Re: Petition No. 1558 - Community Power Group LLC petition for a declaratory ruling, pursuant to Connecticut General Statutes §4-176 and §16-50k, for the proposed construction, maintenance and operation of a 4-megawatt AC solar photovoltaic electric generating facility located at 24 Middle Road, Ellington, Connecticut, and associated electrical interconnection.

Enclosed for filing with the Connecticut Siting Council ("Council") are Community Power Group LLC's ("CPG" or the "Company") responses to the Council's second set of interrogatories dated April 6, 2023.

24 MIDDLE - ELLINGTON SOLAR PROJECT
4.0 MW ARRAY

SITE SUMMARY

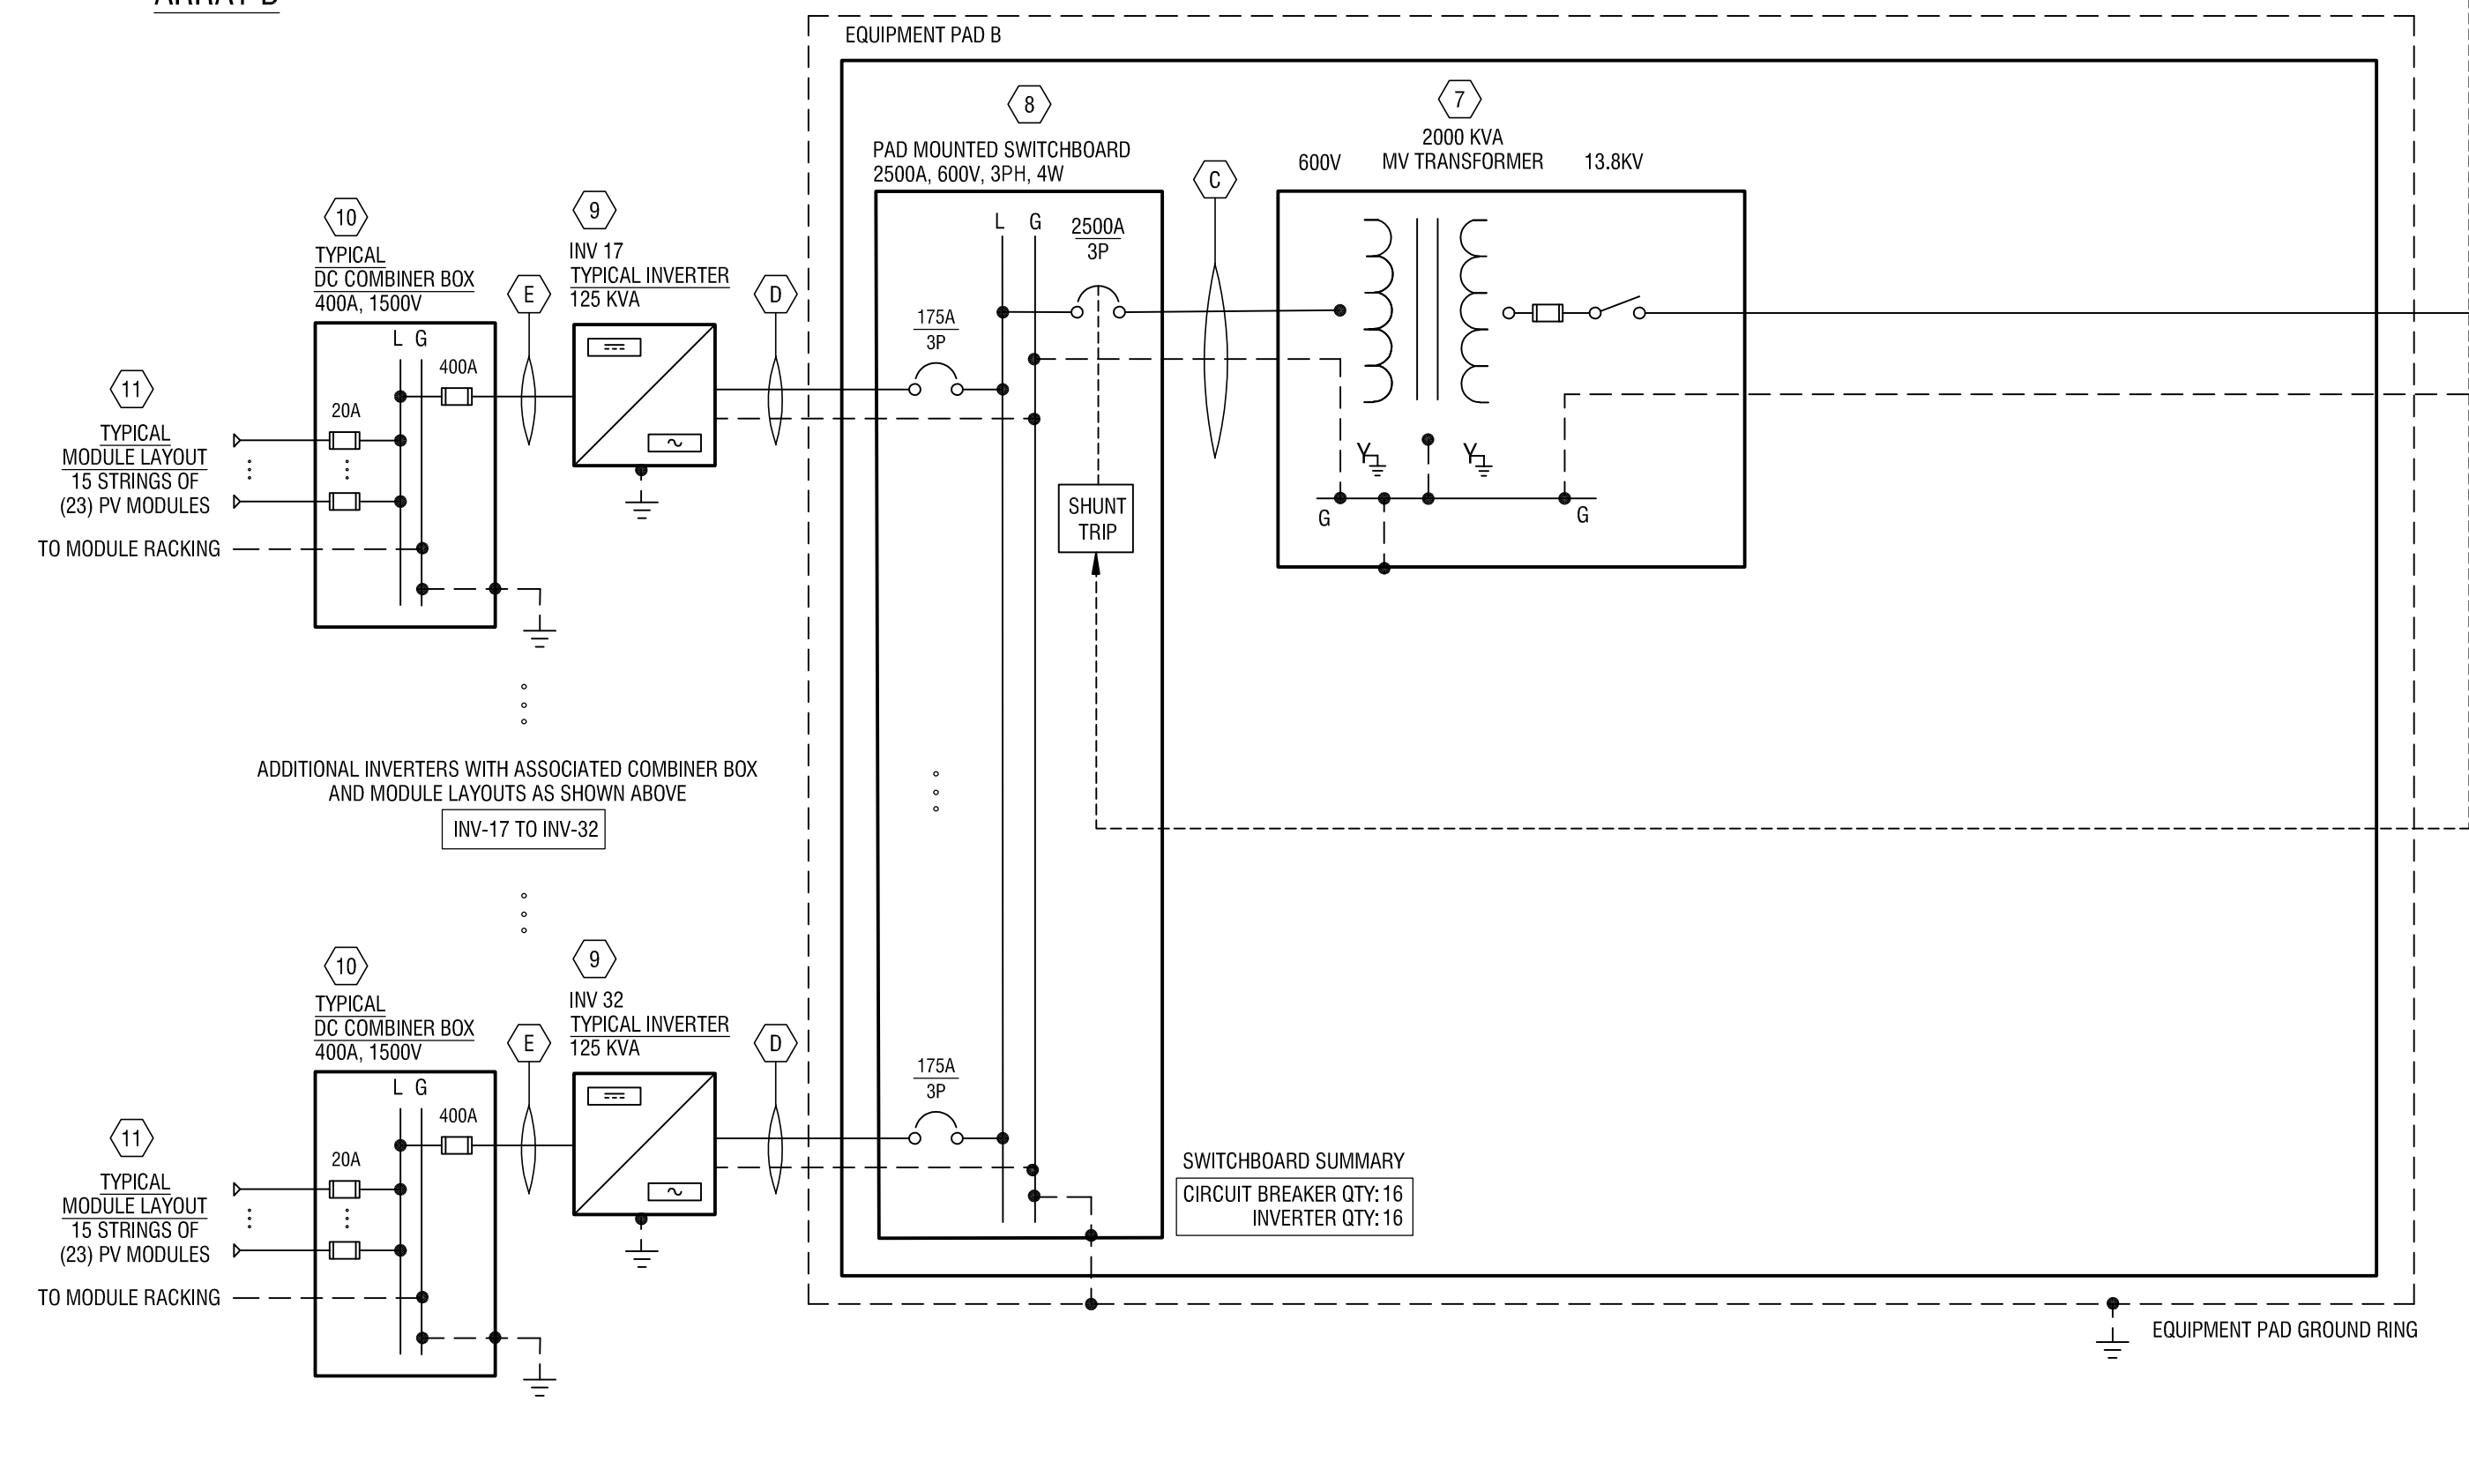
Q-CSC-47: Provide a one-line diagram of the interconnection facilities identifying both overhead and underground equipment.

A-CSC-47: Please see Exhibit CSC-47-1.
